**309 N Ankeny Blvd**  
**Hintz Dental**

*Plan and Zoning Commission  
Staff Report*

**Agenda Item:** 309 N Ankeny Blvd – Hintz Dental Site Plan  
**Report Date:** August 16, 2017 *ESC*  
**Prepared by:** Derek Silverthorn  
Planner I

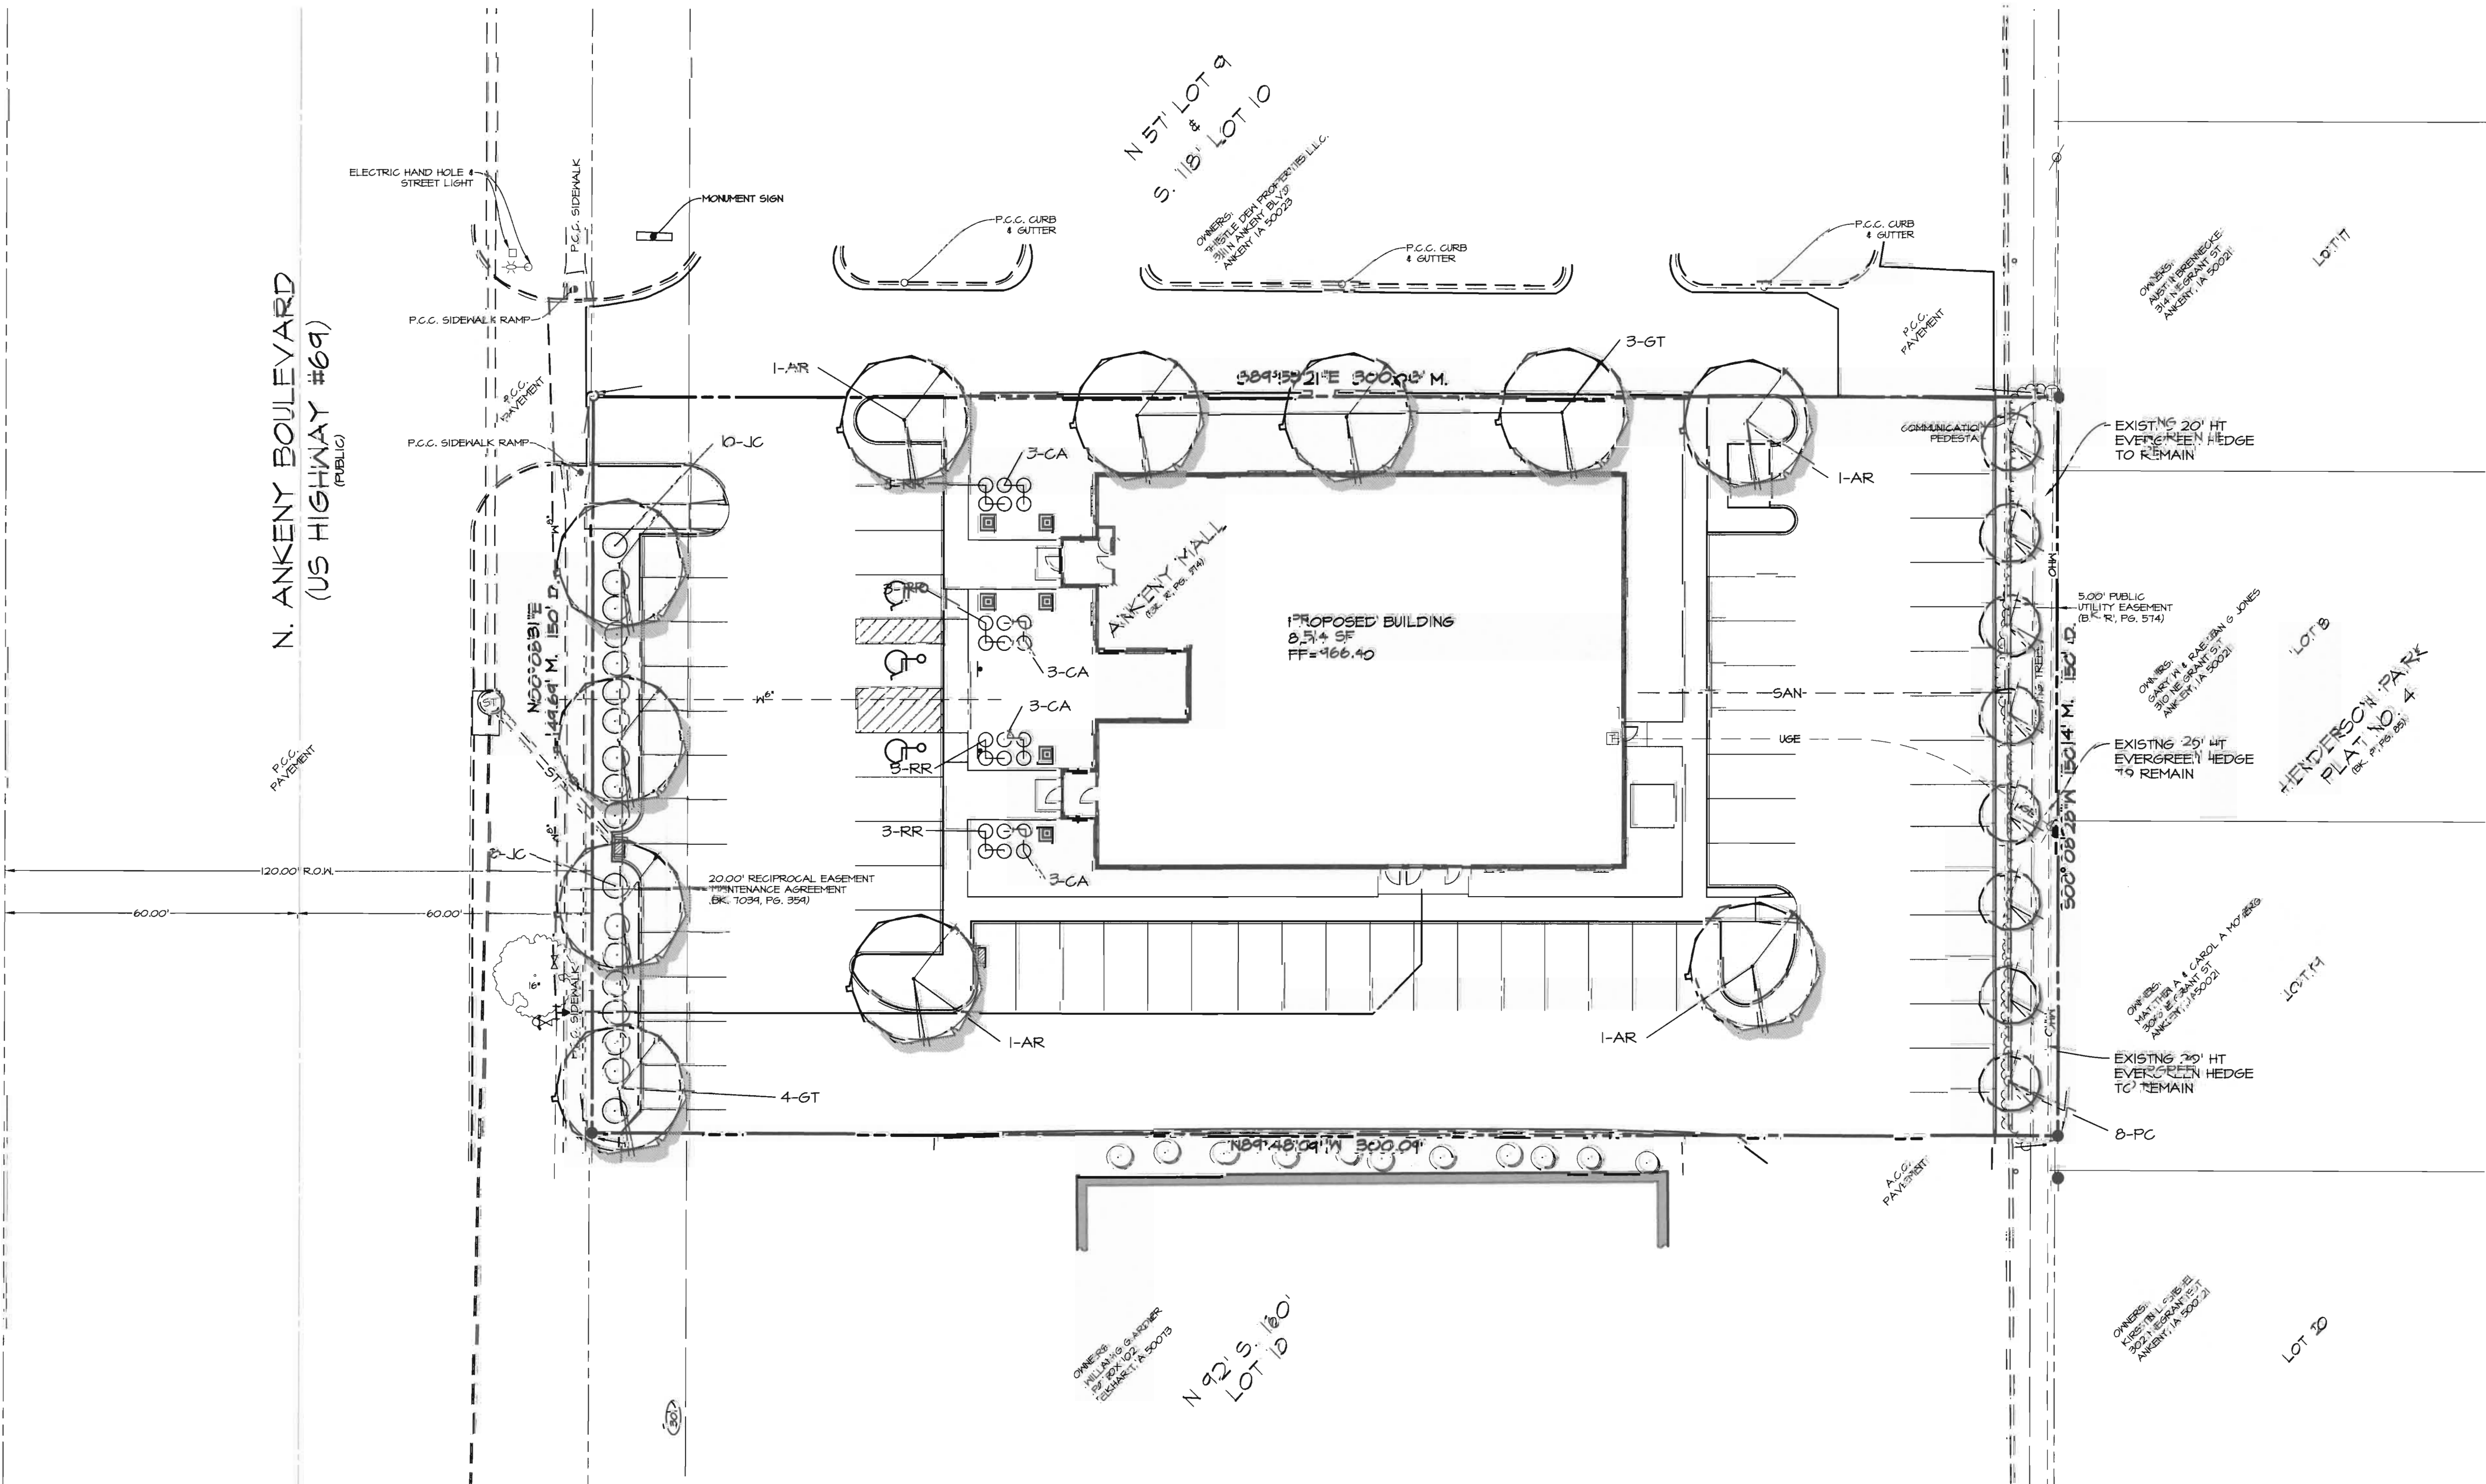
Parking is located on the west, south, and east sides of the building, and meets the requirements for off-street parking as stated in Chapter 194.01(6) (A). Screening is required along the east property line, and is existing via a 20' tall evergreen hedge. Headlight screening is also required along N Ankeny Blvd, and will be satisfactorily provided.

12. **Landscaping shall enhance architectural features and contribute to the beauty and utility of a development. Existing trees should be protected whenever possible to maintain the maturity of the site.**

The proposed landscaping generally conforms to the open space requirements of the code.

**DWG. LIST**  
COLORED EXTERIOR  
ELEVATIONS

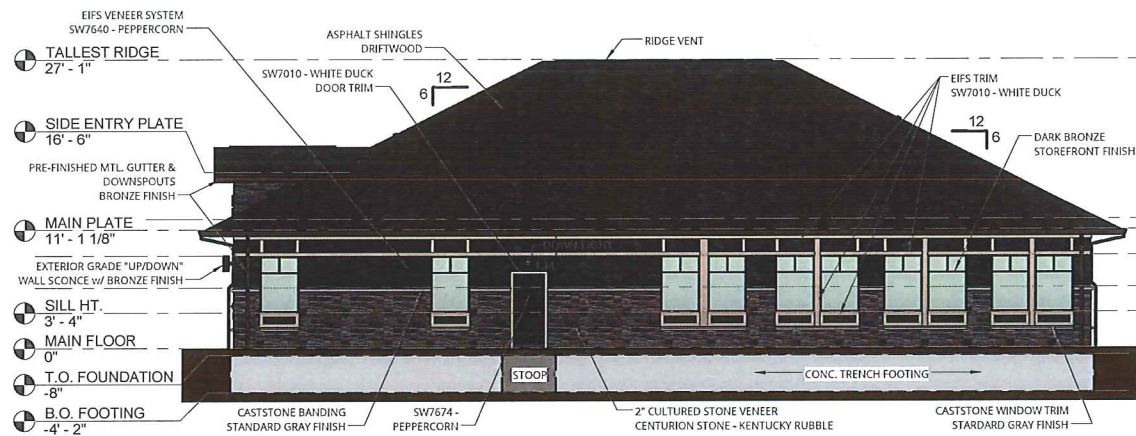
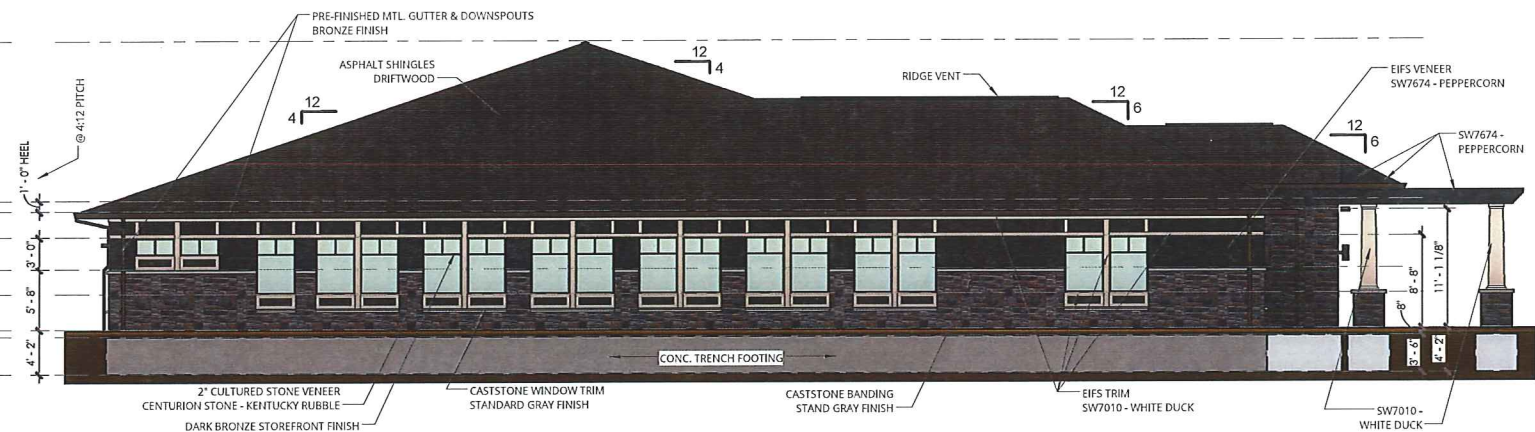
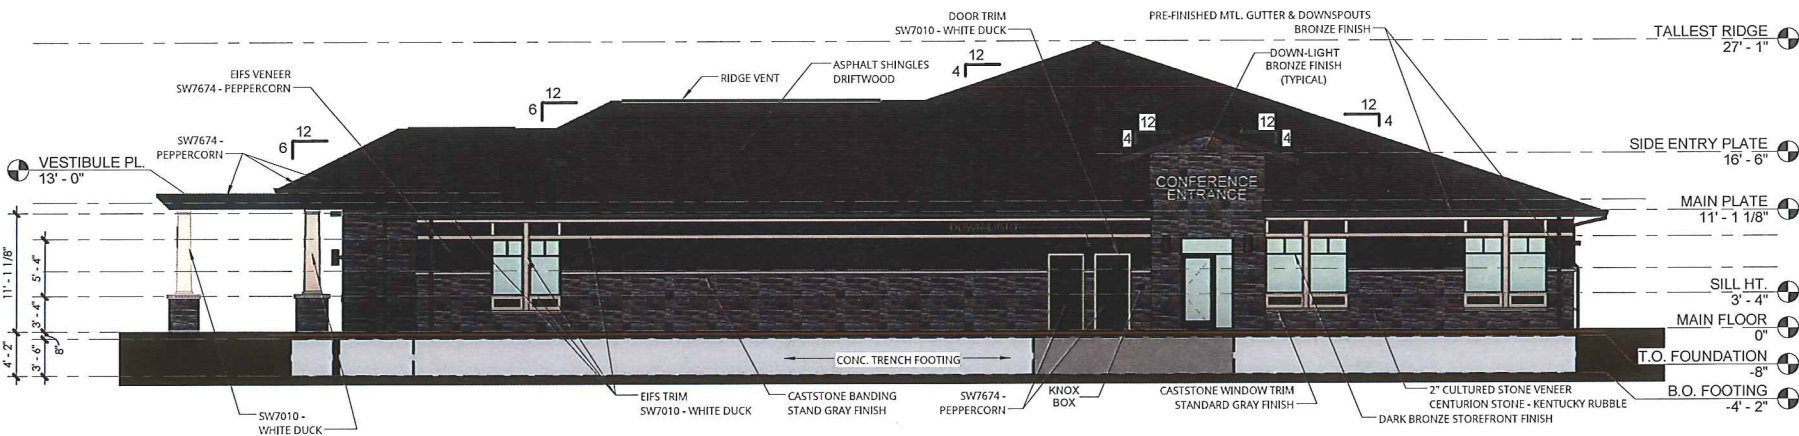
The proposed building is a single-story dental office building with additional lease space, and is 27'-1" to the uppermost point. Adjacent properties to the north and south are 27' and 17' to the uppermost points, respectively.

The proposed materials are a combination of brick, stone, and EIFS.

There are several building signs shown on the elevations. Final design and allowances will be determined with future sign permits.
